SUMMARY OF COMMENTS/RECOMMENDATIONS

PROPONENT: Agassiz Irrigation Association Inc.
PROPOSAL NAME: Hespler Kroeker Irrigation Project
CLASS OF DEVELOPMENT: Two
TYPE OF DEVELOPMENT: Water Development and Control
CLIENT FILE NO.: 5720.00

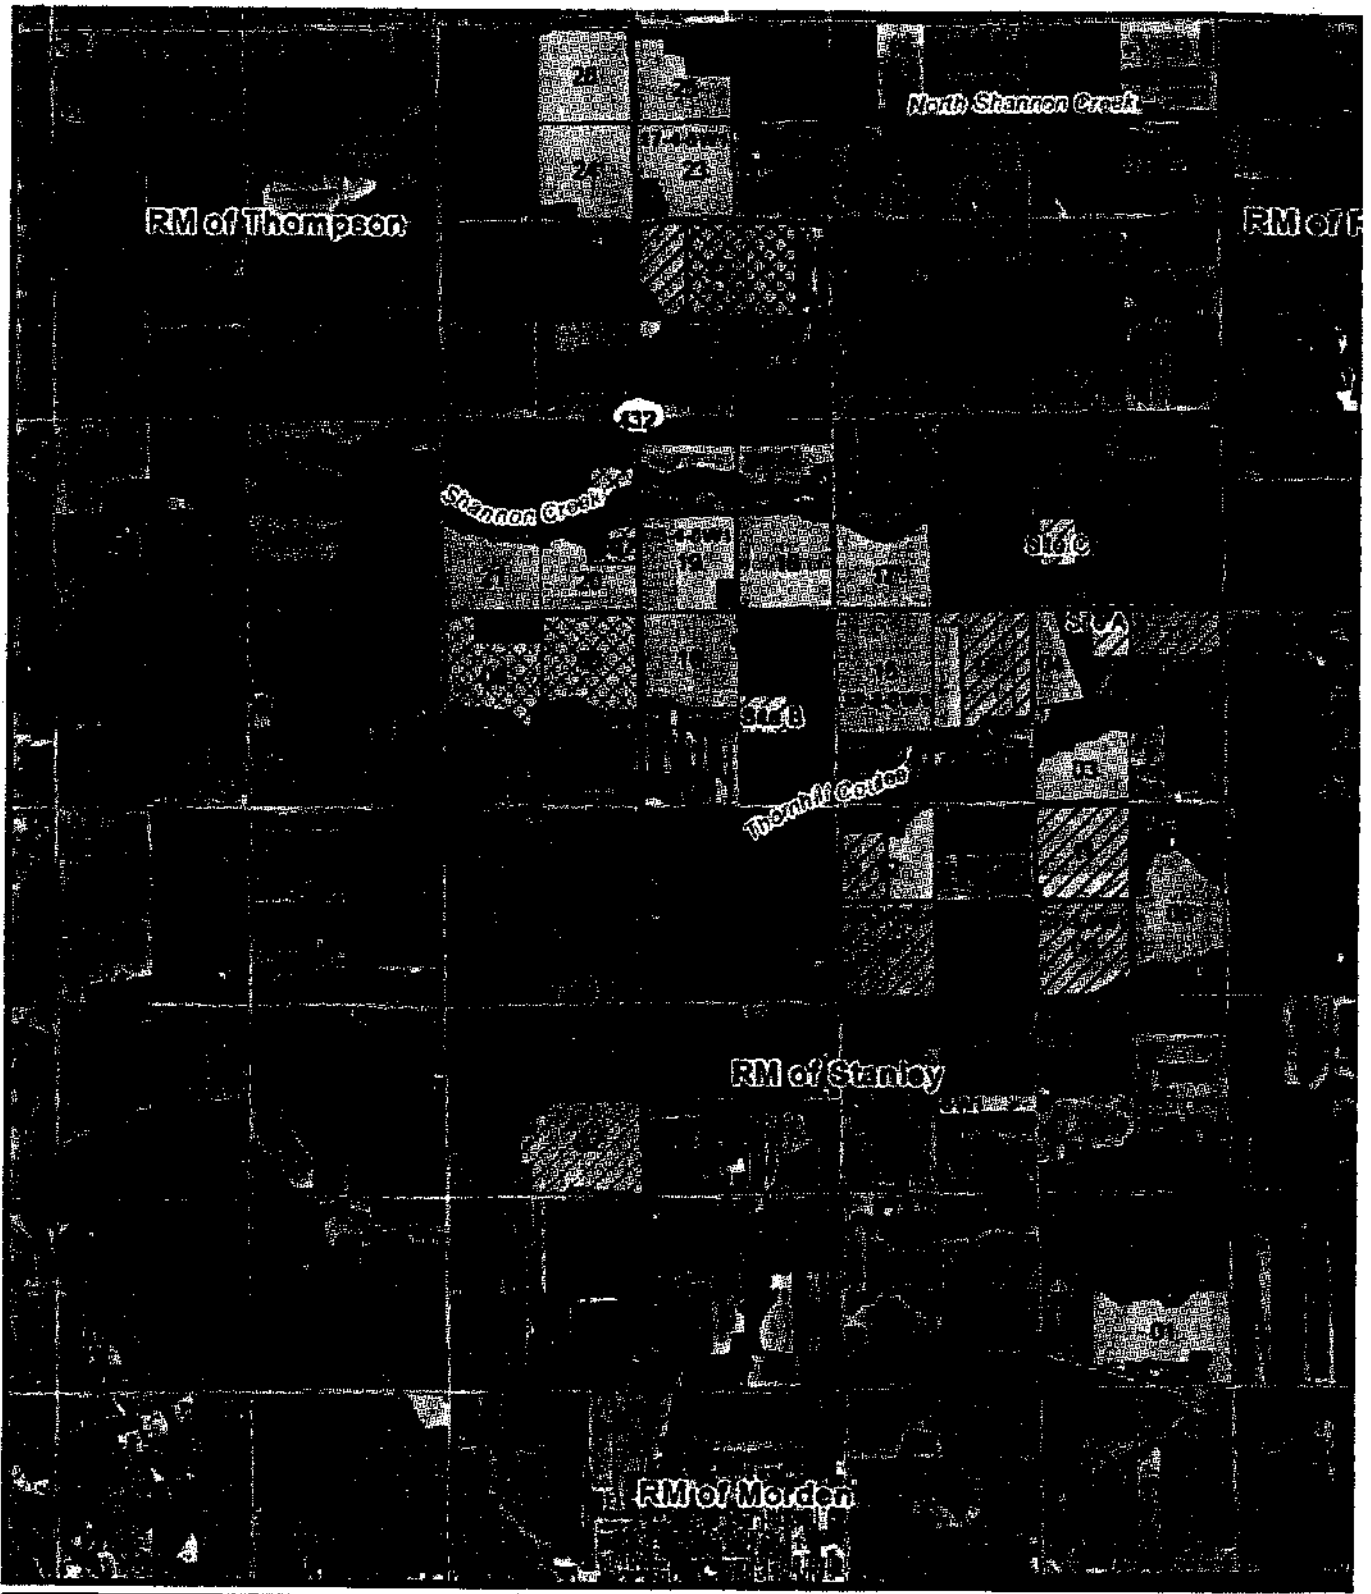
I note that Field 4 – the NW 34 03-05 has the recommendation that sub surface drainage should be improved, however, on the Map Figure 1 this field is not indicated that is "planned for tiling". Can the applicant or consultant clarify the tiling plans, if any, for

I note that Field 8 – the E 27 03-05 has the recommendation that sub surface drainage should be improved, however, on the Map Figure 1 this field is not indicated that is “planned for tiling”. Can the applicant or consultant clarify the tiling plans, if any, for this field, based on the recommendation that the field should have subsurface drainage improvements.

I note that Field 15 – the NW 33 03-05 has the recommendation that sub surface drainage should be improved, however, on the Map Figure 1 this field is not indicated that is “planned for tiling”. Can the applicant or consultant clarify the tiling plans, if any, for this field, based on the recommendation that the field should have subsurface drainage improvements.

I note that Field 16 – the NW 32 03-05 has the recommendation that sub surface drainage should be improved, however, on the Map Figure 1 this field is not indicated that is “planned for tiling”. Can the applicant or consultant clarify the tiling plans, if any, for this field, based on the recommendation that the field should have subsurface drainage improvements.

I note that Field 17 – the SW 04 04-05 has the recommendation that sub surface drainage should be improved, however, on the Map Figure 1 this field is not indicated that is “planned for tiling”. Can the applicant or consultant clarify the tiling plans, if any, for this field, based on the recommendation that the field should have subsurface drainage improvements.

I note that Field 18 – the SE 05 04-05 has the recommendation that sub surface drainage should be improved, however, on the Map Figure 1 this field is not indicated that is “planned for tiling”. Can the applicant or consultant clarify the tiling plans, if any, for this field, based on the recommendation that the field should have subsurface drainage improvements.

I note that Field 19 – the SW 05 -04-05 has the recommendation that sub surface drainage should be improved, however, on the Map Figure 1 this field is not indicated that is “planned for tiling”. Can the applicant or consultant clarify the tiling plans, if any, for this field, based on the recommendation that the field should have subsurface drainage improvements.

I note that Field 20 – the SE 6 04-05 has the recommendation that sub surface drainage should be improved, however, on the Map Figure 1 this field is not indicated that is “planned for tiling”. Can the applicant or consultant clarify the tiling plans, if any, for this field, based on the recommendation that the field should have subsurface drainage improvements. The salinity assessment should be completed as outlined before development occurs.

I note that Field 21 – the SW 6 04-05 has the recommendation that sub surface drainage should be improved, however, on the Map Figure 1 this field is not indicated that is “planned for tiling”. Can the applicant or consultant clarify the tiling plans, if any, for this field, based on the recommendation that the field should have subsurface drainage improvements. There is an indication that there is a potential of weakly saline soils in the Northern portion of the field, and a salinity monitoring program is recommended but there is no assessment indicated. Can the applicant or proponent clarify why there is no assessment required?

I note that Field 22 – the N 8- 04-05 has the recommendation that sub surface drainage should be improved and the Map Figure 1 indicates that part of this field is already tiled and part of this field is “planned for tiling”. The text does not indicated that a portion of the field had been tiled and does not indicated the time lines of the plan for tiling. Can the applicant or consultant clarify?

I note that Field 23 – the SW 17 -04-05 has the recommendation that sub surface drainage should be improved, however, on the Map Figure 1 this field is not indicated that is “planned for tiling”. Can the applicant or consultant clarify the tiling plans, if any, for this field, based on the recommendation that the field should have subsurface drainage improvements.

I note that Field 24 – the SE 18 -04-05 has the recommendation that sub surface drainage should be improved, however, on the Map Figure 1 this field is not indicated that is “planned for tiling”. Can the applicant or consultant clarify the tiling plans, if any, for this field, based on the recommendation that the field should have subsurface drainage improvements.

I note that Field 25 – the NW 17 -04-05 has the recommendation that sub surface drainage should be improved, however, on the Map Figure 1 this field is not indicated that is “planned for tiling”. Can the applicant or consultant clarify the tiling plans, if any, for this field, based on the recommendation that the field should have subsurface drainage improvements.

I note that Field 26 – the NE 18 -04-05 has the recommendation that sub surface drainage should be improved, however, on the Map Figure 1 this field is not indicated that is “planned for tiling”. Can the applicant or consultant clarify the tiling plans, if any, for this field, based on the recommendation that the field should have subsurface drainage improvements.

The fields mentioned below have various reasons that they are not "currently" proposed for tiling. Significantly none of the project fields "require" tiling to be considered for irrigation other than for Field 21 which is a special consideration to be mentioned below. The point of identification of the tile was for purposes of consideration for soil and nutrient management (BMPs).

The reasons for not identifying certain fields for tiling are not generally related to whether they would benefit from drainage. The majority of land in the project area are Imperfectly drained and by definition would benefit from tile. Their are pockets of more well drained soils (e.g. Hochfelds). The main benefit from tile is to reduce saturation in spring and fall, not to prevent water table increase due to leaching from supplemental irrigation.

1. Land ownership; much of land identified by Kroekers is leased or rented land including fields 8, 15, 16, 17, 18, 20, 21, 23, 24 and 26. Tile is a more permanent improvement than irrigation which can be rotated from field to field. Hence the development of irrigation will usually precede plans to tile drain on leased land. Relationships and long term arrangements are required to ensure access. Capital to install tile and subsequent land improvements are tied to these lease arrangements.

2. In some cases relationships have been established and long term arrangements made, which have afforded tile to proceed, including fields 22, 14, 12, 10. In the case of field 22, tiling is occurring on an as needed (crop rotation) basis, with plans to tile the complete field as shown in Figure 2.

3. In some cases the proponents own the land, fields 9, 11, 13, 19, 25, 01, 02, 03, 04, 05, 06, 07. On these fields the decision to tile is based on drainage rather than irrigation suitability questions. Fields 3 and 4 for example are somewhat naturally drained by the beach ridge and the Thornhil Coulee. Producers may have prioritized those fields they felt needed tile drainage the most.

4. For Field 21, some slight salinity is noted. Given that this field is a recent addition to the project, Veris mapping has and will be recommended to be completed PRIOR to accepting it for irrigation suitability. This could be done as early as this fall, depending on priority and funds.

5. Capital availability and time horizons. It is quite possible that all fields will be tiled but that is not a guarantee nor a current (e.g. 5 year) intention. As such it did not seem reasonable to identify a timeline for tiling.

In summary, tilling is NOT a prerequisite to irrigation of these lands, it is more a consideration for soil and nutrient management BMPs that may be possible. Having said this Field 21 is a special consideration depending on the severity and extent of salinity existing which would be the subject of a Phase 2 investigation.

It is recommended that Field 21 be considered conditional for approval pending further studies by the proponents and approval from Manitoba Conservation.
